**Location:** 1618 Clinch Ave. **Parcel ID** 94 N H 013  
**District:** Ft. Sanders NC  
**Zoning:** O (Office)

Level III Construction of New Primary Building

**12-I-25-HZ**  
**APPLICATION FOR CERTIFICATE OF APPROPRIATENESS**

**1618 Clinch Ave. 37916**  
**Ft. Sanders NC Ft. Sanders NC**

1  
 A4.1  
**ELEVATION - REAR**  
 SCALE: 1/4" = 1'-0"  
 1616 CLINCH

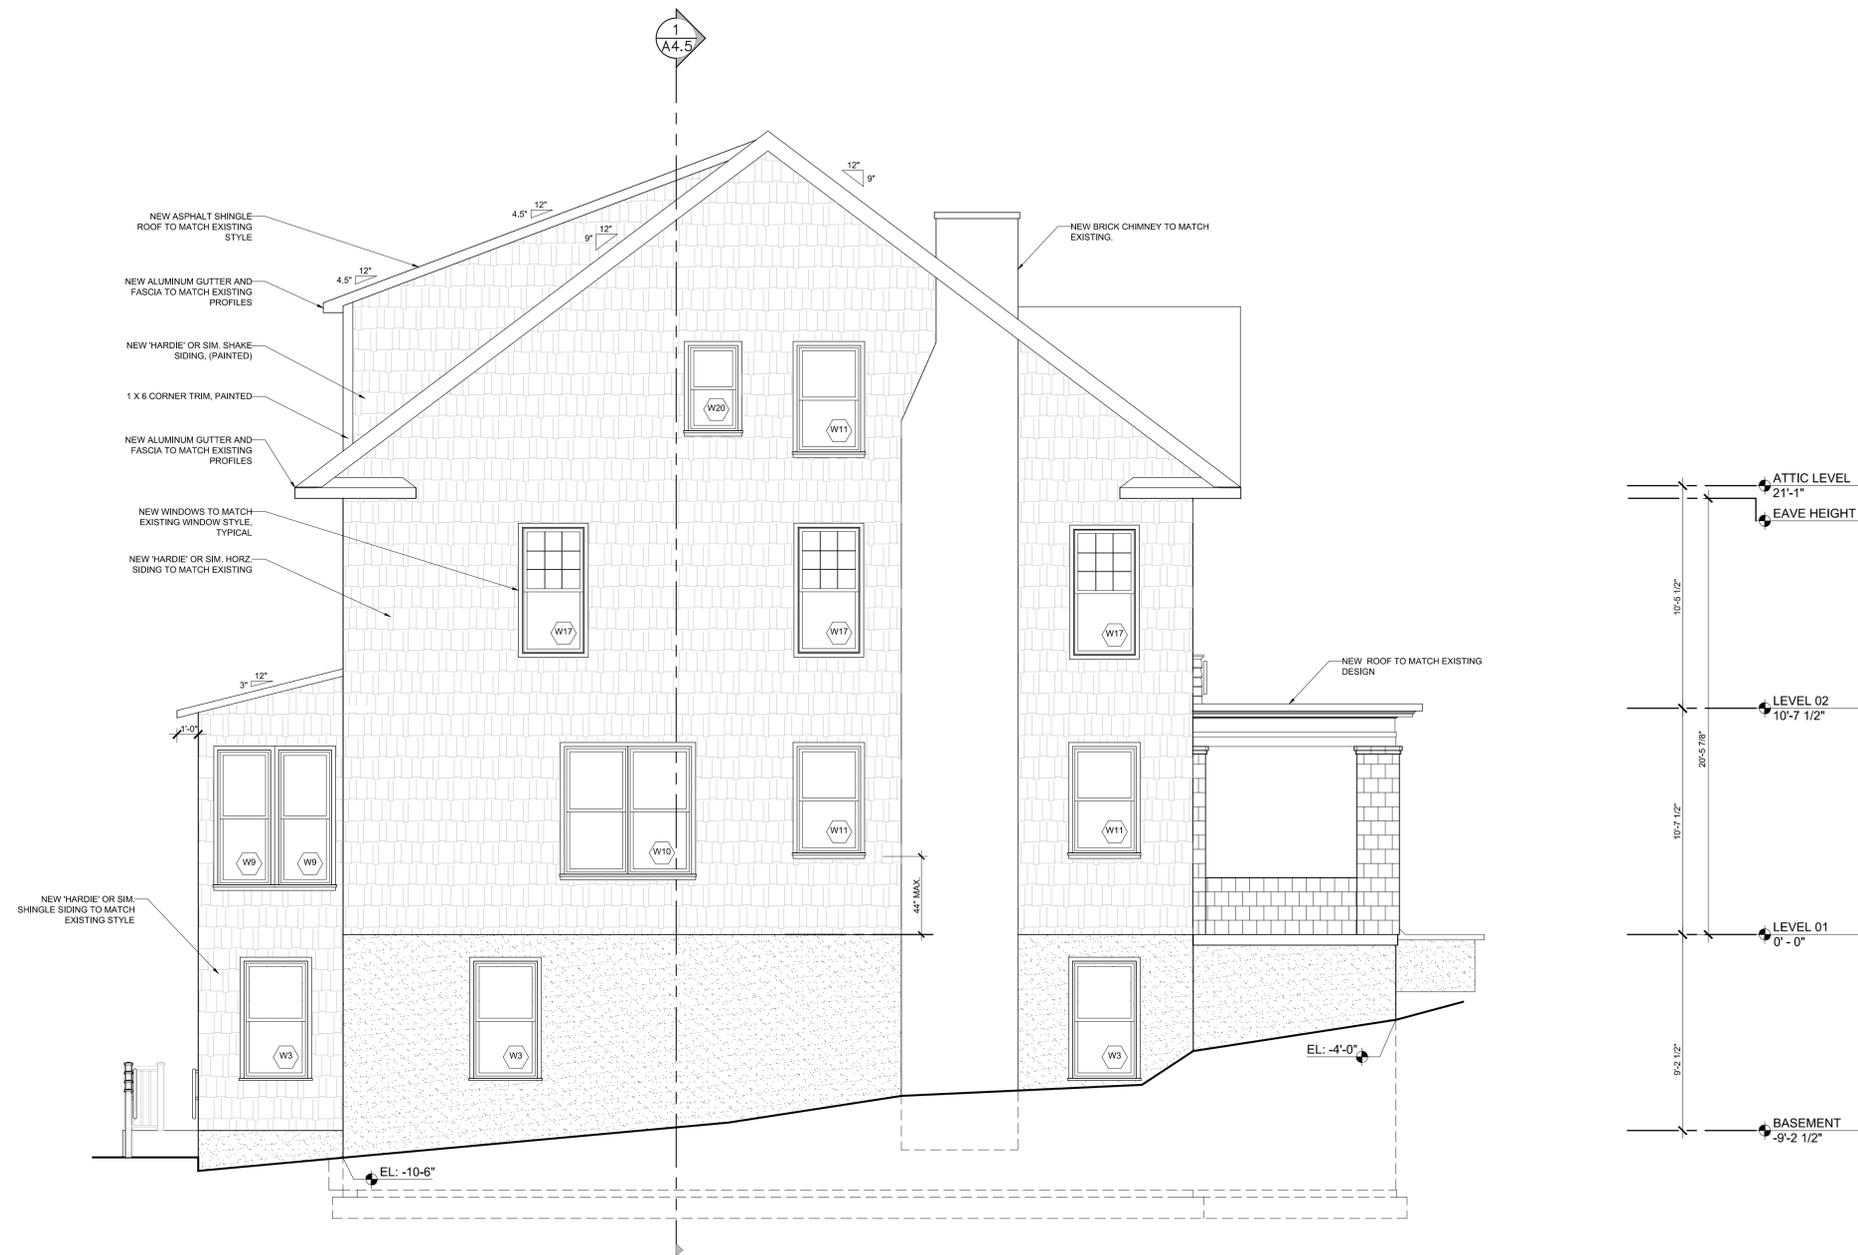
4. The proposed front and side exterior elevations match those of the renovation plans approved in May 2025, with the following exceptions to the side elevations. The rear elevation is not visible from the street and only has minor changes.

1  
A4.2 ELEVATION - LEFT  
SCALE: 1/4" = 1'-0" 1618 CLINCH

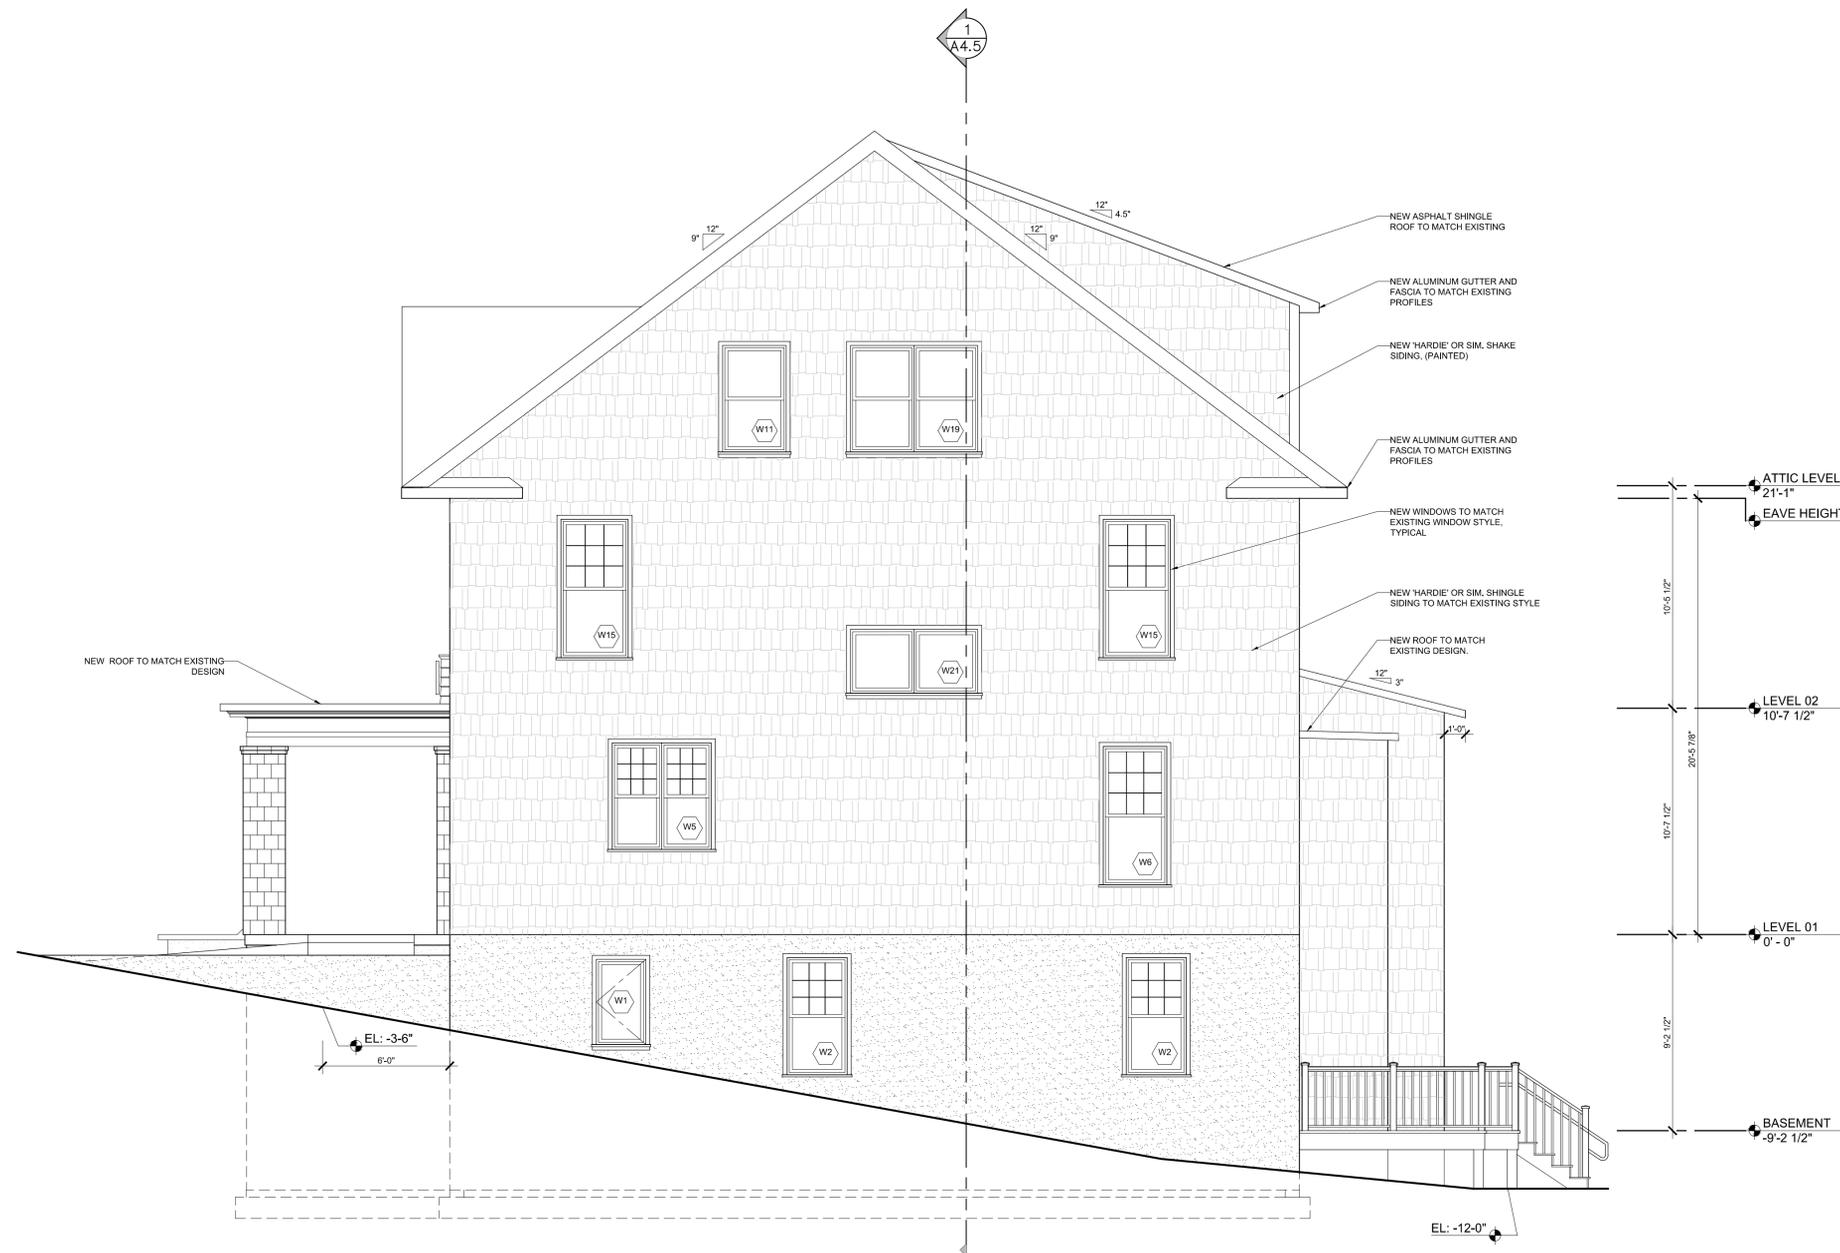
b) Left (east) side – two 9/1 windows towards the rear of the house were changed to 1/1 windows, and a new 1/1 window was added near the front.
